## **CABINET MEMBER FOR TRANSPORT - 24 MARCH 2011**

### **OXFORD, THE SLADE AND HORSPATH DRIFTWAY, CYCLE AND PEDESTRIAN IMPROVEMENTS**

**Report by Deputy Director of Environment & Economy – Highways & Transport**

Project title	The Slade / Horspath Driftway Cycle & Pedestrian Improvements	
Drawing title	Key Features

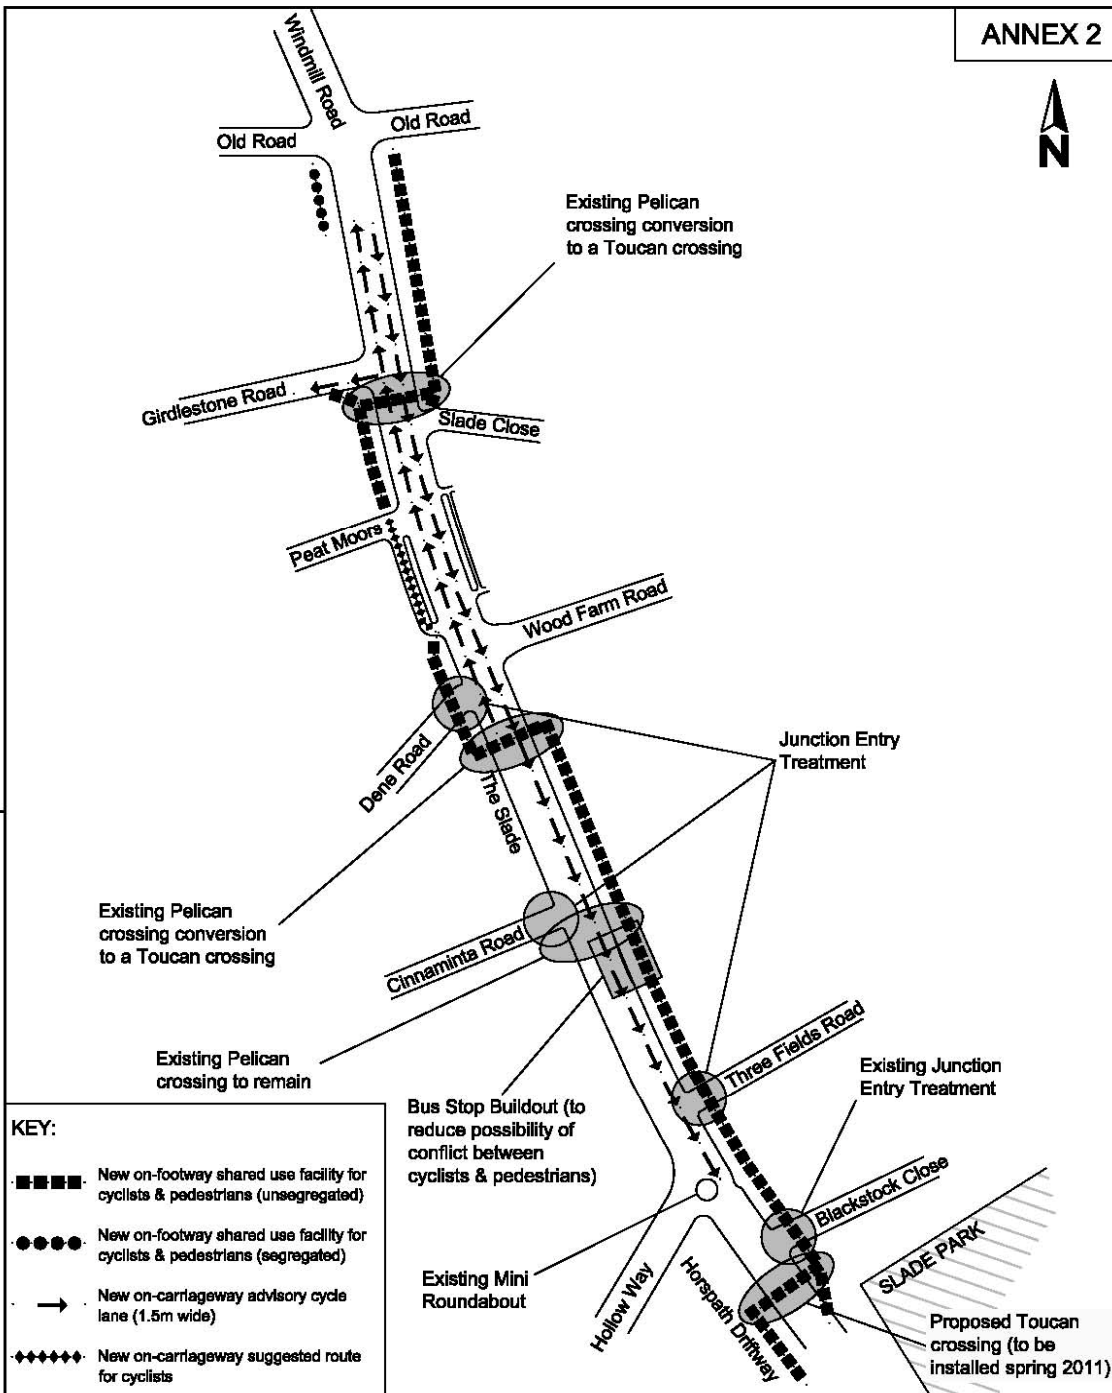
Ref:	Description	Address	Comments	Officer response
1	Local resident	The Slade	<ol style="list-style-type: none"> <li>1. In the opinion of the respondent, '<i>The Slade is unsafe for cyclists, and cyclists [currently] have to get off and walk or cycle on the pavement due to the speed of vehicles</i>'.</li> <li>2. The respondent commented that 'the scheme will help to stop cars parking on the pavements and forcing pedestrians into the road outside number 195 The Slade'.</li> <li>3. The respondent suggested that the scheme should '<i>extend to Old Road heading towards the city centre and Morrell Avenue - [these routes are] wide roads with wide pavements but the roads are very unsafe to cycle on and [road users] should not have to wait for a serious accident involving a cyclist before improvements are made</i>'.</li> <li>4. A further comment was made concerning the speed of traffic on The Slade and suggested '[reducing] the speed limit on The Slade to 20 mph, or put in speed bumps' (but queried the affect on fire engines and ambulances).</li> </ol>	<p>The scheme would address this by providing safe cycle routes.</p> <p>Noted.</p> <p>The proposals extend to Old Road, and there are separate proposals for a cycle route in Old Road.</p> <p>When 20mph limits were introduced across much of Oxford in 2009, The Slade was determined to be suitable for the existing 30mph speed limit to be retained. There are no plans to review this. Vertical deflections on The Slade itself have not been considered as part of this scheme, but the proposals include raised crossings of some side roads, which</p>

Ref:	Description	Address	Comments	Officer response
			<p>4. The respondent suggested that the half width yellow box junction across the Three Fields junction should be extended across the full width of The Slade <i>'to encourage drivers to let right-turners into Three Fields'</i>.</p> <p>5. The respondent commented that they had <i>'not seen a great increase in number of cyclists, perhaps not out at the times leaving for lectures'</i>. Respondent asked if a survey to see how volumes have increased has been considered.</p> <p>6. The respondent disagrees in principle with the idea of cyclists and pedestrians sharing the pavements as <i>'many cyclists are inconsiderate to pedestrians'</i>. Commented that <i>'students are adults and should be able to cycle in the road'</i>.</p>	<p>We would monitor the situation and consider introducing parking controls in the future if necessary. The proposals allow for a yellow box across the whole of the junction mouth, to allow clear entry and exit to Three Fields.</p> <p>A cycle count was carried out but a comparison of the situation before and after the development has not been made. If there has not been a significant noticeable increase this would not be a reason not to create the cycle route – part of its purpose is to encourage more cycling.</p> <p>It is true that a small minority of cyclists are inconsiderate to pedestrians, but accidents between cyclists and pedestrians are thankfully very rare. Officers consider that the risk of conflict is very low and does not outweigh the overall benefits of the scheme.</p>

Ref:	Description	Address	Comments	Officer response
5	Local resident	Inott Furze	<ol style="list-style-type: none"> <li data-bbox="689 263 1288 703">1. The respondent objects to the removal of the right-turn lanes along The Slade explaining that 'they are of great benefit to cyclists who need to turn right across the traffic, the alternative is blocking the traffic behind till the other side of the road clears and motorists get impatient'. Made reference to the existing right turn lane at Peat Moors 'at the top of a short hill and removing it would obviously make turning right difficult.</li> <li data-bbox="689 746 1288 962">2. The respondent considers the right turn lanes as <i>'more important safety features than anything contained in the proposal'</i> and was <i>'amazed to read they 'are not considered essential in safety terms'</i></li> <li data-bbox="689 1005 1288 1369">3. The respondent commented that <i>'there is not room on the pavement for safe sharing with cyclists, allowing cyclists to ride on pavements is just a way of getting them off the road at the expense of pedestrians, safe sharing means pedestrians getting out of the way of bikes, often by stepping off the kerb which bikes can't do once committed to the pavement'</i>.</li> <li data-bbox="689 1412 1288 1474">4. The respondent considers <i>'pavement cycle ways also cause problems for on</i></li> </ol>	<p data-bbox="1310 263 2087 408">The scheme proposals would not reduce the overall carriageway width so when cyclists position themselves to turn right, vehicles going straight ahead will still be able to pass them.</p> <p data-bbox="1310 708 2087 853">If right turn lanes were considered essential they would need to be introduced at every junction, and this is clearly not the case. In fact there are many busy junctions on urban roads without them.</p> <p data-bbox="1310 930 2087 1331">The available footway widths are above the Department for Transport recommended minimum widths for shared use cycle paths. It is not our purpose to remove cyclists from the road if they wish to cycle on the road. This is demonstrated by the introduction of on-carriageway cycle lanes for the more confident cyclist. Pedestrians still have priority on the footway and most cyclists will slow down and give way to pedestrians, not wanting to risk a collision. The footway widths allow pedestrians and cyclists to safely avoid one another.</p> <p data-bbox="1310 1412 2087 1474">In this situation the cyclist on the road would have overtaken the cyclist on the footway and so would be</p>

6	Local resident	The Slade	<p>1. The respondent supported the new Toucan crossing and bus stop markings on Horspath Driftway.</p> <p>2. Concern was expressed regarding the <i>'removal of [right turn lane] road markings on The Slade as a lot of traffic turns right at the Wood Farm Road'</i>. The respondent is of the opinion that if the existing right turn lane were to be removed to accommodate the proposed cycle</p>	<p>Noted.</p> <p>The scheme proposals would not reduce the overall carriageway width and the centre line would be removed, so when drivers position themselves centrally to turn right, it is likely that vehicles going straight ahead would be able to pass them. The cycle lane is mandatory so drivers could over-run it when a cyclist is not present (as is the case with most other on-carriageway cycle lanes in Oxford).</p>

Ref:	Description	Address	Comments	Officer response
9	Oxford resident	Church Cowley Road	<ol style="list-style-type: none"> <li data-bbox="689 263 1288 560">1. The respondent commented that <i>'as a cyclist I will not use shared-use pavements, because they have to give way to everything and are therefore slower. They also encourage drivers to think cyclists have no right to be on the road.....and are dangerous for pedestrians'</i>.</li> <li data-bbox="689 596 1288 845">2. The respondent expressed concern that shared use footways would be open to use by all cyclists and not just the less confident ones and concluded that <i>'shared use pavements are also likely to make the problem of illegal pavement cycling worse'</i>.</li> </ol>	<p data-bbox="1310 263 2087 411">Cycle routes on the footway are intended for less confident and slower cyclists. The scheme would provide on-carriageway cycle lanes for more confident cyclists along much of The Slade.</p> <p data-bbox="1310 596 2063 815">It is true that the facilities would be open to use by all cyclists but cyclists wishing to go fast are likely to choose the on-carriageway lane. Officers do not believe there is strong evidence that clearly marked, official shared use footways encourage more illegal footway cycling elsewhere.</p>

Ref:	Description	Address	Comments	Officer response
			<p>Windmill Road / Old Road signal controlled junction.</p> <p>3. Support was also given for the new road markings at the Hollow Way roundabout (Slade approach), but was qualified with the suggestion of <i>'marking cycle lanes on the other two corners [of the roundabout]. There can be a cycle lane from the roundabout to just past Three Fields - there is little demand for parking on this stretch'. [east side of The Slade].</i></p> <p>4. Further suggestions were made by the respondent as follows:</p> <ul style="list-style-type: none"> <li>• dropped kerbs at the ASL located on The Slade (Windmill Road junction) should extend across the full length of the lead-in lane and the full length of the ASL.</li> <li>• Large cycle logos in the left hand on the road <i>'to encourage appropriate motorists.....and to encourage cyclists to take the lane'</i></li> </ul>	<p>Informal, daytime parking on this stretch does present a problem. For cyclists coming from Hollow Way, there is an alternative, parallel route via Bulan Road. Cyclists coming from Horspath Driftway can use the new Toucan crossing and the off-carriageway facility.</p> <p>Dropped kerbs will cover the length of the lead-in taper and just over half the length of the ASL, an overall length of 6.00 metres. This provides a generous length of dropped (flush) kerbs for cyclists using the off-carriageway facility to drop back into the ASL, including situations when cars are stopped for the traffic signals. Providing a longer length of dropped (flush) kerb would require additional road drainage gullies.</p> <p>Queueing traffic would cover the markings when they would be most useful. They would increase road marking clutter. The symbols may also give the impression that the left turn filter lane was intended for cyclists only (because this lane is only 2.50 m wide).</p>

Ref:	Description	Address	Comments	Officer response
			<ul style="list-style-type: none"> <li>• Removal of the kink in the alleyway (adjacent Dene Road) through to Leiden Road to 'provide a clear link from those roads to the new cycle route'</li> <li>• A cycle lane across the mouth of Cinnaminta Road (from the start of the double yellow lines opposite the bus stop to the bus stop)</li> <li>• Consider marking a <i>'cycle lane despite the parking on the south side [of The Slade] perhaps a 2m [wide] cycle lane with 1m painted build outs or [access protection] bars across driveways'</i></li> </ul>	<p>This alleyway is not sufficiently wide to allow safe cycling.</p> <p>See response to point 3 above. There is also a bus stop immediately adjacent to Cinnaminta Road.</p> <p>If the purpose of this is to provide a cycle lane past parked cars, it assumes they are parking on the footway (which we would not want to encourage) and even if they are, it is questionable whether there would be sufficient safe space for cycles. In any case, cyclists may want to be well out into the road, away from opening doors. Drivers can often wrongly expect cyclists to stay in their lane, which can be intimidating for cyclists wanting to take a position further out into the road.</p>

12	Oxford resident		<ol style="list-style-type: none"> <li>1. The respondent objected to the removal of the right turn lanes on The Slade on the basis that <i>'traffic will not have a marker for the correct positioning to allow traffic to pass besides them, to leave room for all traffic approaching'</i>.</li> <li>2. The respondent commented specifically about Cinnaminta Road <i>'where traffic is over the centre line in order to pass parked cars'</i>. On the</li> </ol>	<p>Most drivers would be able to judge the suitable road position, particularly when they became accustomed to the route.</p> <p>Parking less than 10m from a junction is contrary to the Highway Code. Removing guard rail would make it easier for someone to park so as to cause an obstruction, but the risk would be outweighed by the</p>

13	On behalf of Unlimited		<p>The respondent:</p> <p>1. asserts that the only people to benefit from the proposal will be the students in Slade Park;</p>	<p>The benefits of the scheme would be much wider and are discussed fully in the report.</p>

Ref:	Description	Address	Comments	Officer response
			<ol style="list-style-type: none"> <li>2. asserts that students are adults and therefore should be able to cycle safely on the road – also that they do not need to cycle at peak traffic times;</li> <li>3. is concerned that the footway is narrowed in places by the presence of street furniture, and that there will be insufficient space around the bus stop;</li> <li>4. is concerned about people with low vision/hearing disability who may not detect an approaching cyclist;</li> <li>5. is concerned about sight lines at exits from properties being obscured by hedges;</li> <li>6. is concerned about people with disabilities and mobility impairment avoiding The Slade, and the risk that this would reduce their independence;</li> <li>7. asserts that ‘young, healthy able bodied people are being given priority above those vulnerable members of our community who deserve recognition’;</li> </ol>	<p>Just because they are adults does not mean that they are experienced or confident cyclists. Many students do in fact need to travel to lectures and other teaching during peak times.</p> <p>The design takes account of this, and street furniture would be moved where necessary. The footway would be widened sufficiently at the bus stop.</p> <p>Officers accept that there is a risk that shared use cycle tracks can be intimidating for blind people and those with low vision, as well as people with other disabilities, including hearing loss. However, the scheme has been carefully designed, following Department for Transport Guidelines, to ensure adequate footway widths and visibility (in this case the cyclist being able to see the pedestrian). This issue is further discussed in Annex 5 of this report.</p> <p>The risk to vulnerable road users is very low and needs to be considered in conjunction with the wider benefits of the scheme, discussed in the report. Aspects of the design such as raised side road entry treatments improve conditions for elderly or physically impaired pedestrians</p>

Ref:	Description	Address	Comments	Officer response
			<p>5. is concerned about drainage leading to ponding on the west side of The Slade;</p> <p>6. welcomes the removal of guard rail at Cinnaminta Road;</p> <p>7. suggests installing new seating on the route;</p> <p>8. suggests signage in the service road warning motorists of the presence of cyclists.</p>	<p>Comment noted – this is a matter for maintenance, except at locations where the scheme involves moving the kerblines, where drainage has been taken into consideration.</p> <p>Support noted (6).</p> <p>Regretably this is not affordable within the scheme budget.</p> <p>Cycle symbols could be painted on the carriageway.</p>

Ref:	Description	Address	Comments	Officer response
				<p>would slow turning traffic. Removal of central white line markings and introduction of advisory cycle lanes would visually narrow the road and give drivers a less defined path, with the aim of changing driver perceptions and causing them to moderate their speed.</p>
2	Local residents (2)	The Slade	<p>1. The respondent commented that the <i>'proposed scheme looks great, is well overdue and has our full support'</i>.</p>	Support noted
3	Local resident	Leiden Road	<p>1. The respondent expressed concern over the removal of the right turn lanes into Three Fields and Wood Farm Road, explaining that <i>'traffic gets very congested in that area as there is a lot of parking blocking the left hand lane, therefore removal [of the right turn lane] will increase congestion'</i>.</p> <p>2. The respondent suggested <i>'double yellow lines should be provided at the junction to Three Fields to stop vehicles parking to close to the junction.....and the current proposals make [the situation] worse'</i>.</p> <p>3. Commenting on the proposed raised junction treatment at the Three Fields junction, the respondent said <i>'the raised junction could make [the situation] more dangerous without double yellow lines'</i>.</p>	<p>The scheme proposals would not reduce the overall carriageway width and the centre line would be removed, so when drivers position themselves centrally to turn right, it is likely that vehicles going straight ahead would be able to pass them. The cycle lane is mandatory so drivers could over-run it when a cyclist is not present (as is the case with most other on-carriageway cycle lanes in Oxford).</p> <p>The situation relative to the parking would not be made any worse as a result of this scheme.</p> <p>The proposed change to the junction geometry is more likely to reduce the likelihood of people parking at the junction in Three Fields. Although it could make it easier to park nearer to the junction on the east side of The Slade, parking does not tend to occur on this side.</p>

Ref:	Description	Address	Comments	Officer response
			<p><i>road cyclists who have to try and check behind their shoulder for pavement cyclists speeding up the inside before they can turn left'.</i></p> <p>5. Pavement cyclists are not necessarily slower and, as less experienced cyclists, they often have no concept of when to watch out for and give way to road cyclists and traffic.</p> <p>6. The respondent suggested a cycle route through the residential streets of the new Eastfield Estate to Holloway could be promoted for 'less experienced cyclists'.</p> <p>7. However, the respondent does agree with the provision of the crossing [on Horspath Driftway?].</p>	<p>aware of the risk. In any case, turning cyclists should always check for pedestrians on the footway and would be unlikely not to notice a cyclist about to cross.</p> <p>See above comment – it is assumed that cyclists on the road would be more experienced and look out for them.</p> <p>There is no available link between East Field Close and Hollow Way.</p> <p>Noted.</p>

Ref:	Description	Address	Comments	Officer response
			<p>lanes <i>'any vehicle turning will hold up the traffic behind it until a vehicle coming in the opposite direction allows it to cross at many hours of the day there is no break in the traffic'</i>.</p> <p>3. The respondent commented that by providing cycle lanes <i>'there is a great danger of cyclists coming fast up the inside and being invisible to turning traffic'</i>.</p> <p>4. The respondent commented that he thought the localised footway build out at the junction between The Slade and Peat Moors service road was <i>'a large expense for an occasional problem'</i>. The respondent queried whether road markings could be used instead to achieve the same result.</p> <p>5. The respondent was unconvinced by the <i>'expense of raised entries, where vehicles lurch as they find it difficult to get the right acceleration when they have to cross them and make the road/path less safe for pedestrians'</i>.</p> <p>6. The respondent questioned the gap between the proposed bollards at the alley way cut throughs on the east side of The Slade, making particular reference to <i>'sufficient [width] for</i></p>	<p>(3) This is a risk at junctions, but one that most cyclists are aware of, particularly when passing queuing traffic. At junctions without yellow boxes the cycle lane is marked across the junction mouth, making drivers aware of the cycle lane as they turn. The yellow box junction with Wood Farm Road has a wide mouth and therefore good visibility between oncoming cyclists and right turning cyclists. The yellow box junction at Three Fields could be extended to improve visibility, but the raised entry treatment would in any case slow turning traffic.</p> <p>(4) There is a high level of parking demand in this service road, with vehicles frequently parking on the corner. A build out would physically prevent this and allow cyclists space to enter the service road from the footway.</p> <p>(5) The gradient of the raised entry treatment would not be steep enough to cause this to happen.</p> <p>Widths have been checked and are in accordance with the Department for Transport's 'Inclusive Mobility' guidance document.</p>

Ref:	Description	Address	Comments	Officer response
			<p><i>unmounted bicycles and electric scooters as this route can be used instead of the main road?</i></p> <p>7. The respondent questioned the business case for progressing with the scheme [Section 106 money].</p> <p>8. Questioned if OCC were going to liaise with Oxford Brookes University to promote cycling when the scheme is Implemented.</p>	<p>The relevant S106 contribution is restricted to providing a safe cycle route between Slade Park and Oxford Brookes University Campus. The scheme is fully funded from developer contributions thus does not place a burden on other funding sources or detract from the council's ability to spend on other items. Oxford Brookes University does promote cycling, and the county council supports them in this.</p>
7	Relative of local resident		<p>1. Sent in on behalf of the respondent's father. The respondent expressed concern regarding the two sections of proposed unsegregated footway/cycle route near Girdlestone Road and Dene Road <i>'as it will put the most vulnerable pedestrians at risk from cyclists'</i>. The respondent's father is blind and walks from The Slade to Old Road on a daily basis. According to the respondent, the proposals will <i>'cause [her father] difficulty and increased stress'</i>.</p> <p>2. The respondent finds the shared facilities <i>'stressful due to the high speed of cyclists'</i>. The respondent commented that <i>'the visually impaired do not have the luxury of walking in the road or moving to allow cyclists to pass. Other vulnerable people such as</i></p>	<p>Officers accept that there is a risk that shared use cycle tracks can be intimidating for blind people and those with low vision. However, the scheme has been carefully designed, following Department for Transport Guidelines, to ensure adequate footway widths and visibility (in this case the cyclist being able to see the pedestrian). This issue is further discussed in Annex 5 of this report.</p> <p>Officers also recognise the potential impact on elderly and disabled people. Again, this is further discussed in Annex 5 of this report.</p>

Ref:	Description	Address	Comments	Officer response
			8. and suggests that students should instead be educated to ride safely and responsibly.	The Universities promote safe cycling and Oxford Brookes University has previously offered cycling training and has plans to do so in the future.
14	Local City Councillor Bob Timbs		Respondent does not have any problems with the proposed cycle facilities and has had no complaints from residents. He has concerns about parking in Blackstock Close.	Support noted. Parking in Blackstock Close is being monitored.
15	Local County Councillor Val Smith		Very happy with the proposals.	Support noted.
16	Travel Choices Team, Oxfordshire County Council		<p>The respondent:</p> <ol style="list-style-type: none"> <li>1. shares concerns about shared use footways, but accepts the limitations of on-road facilities in this location;</li> <li>2. has concerns that the footway is narrowed in places by obstructions such as signs;</li> <li>3. proposes road markings, signs and information should make it clear that pedestrians have priority on shared use footways;</li> <li>4. suggests that seating is improved in the bus shelter;</li> </ol>	<p>Noted.</p> <p>Street furniture including signs would be moved as necessary – this has been allowed for in the design.</p> <p>The county council is restricted to using Department for Transport approved signage. However, additional markings on the footway could be considered.</p> <p>Replacement of the bus shelter is out of scope, as it would not be affordable within the scheme budget.</p>
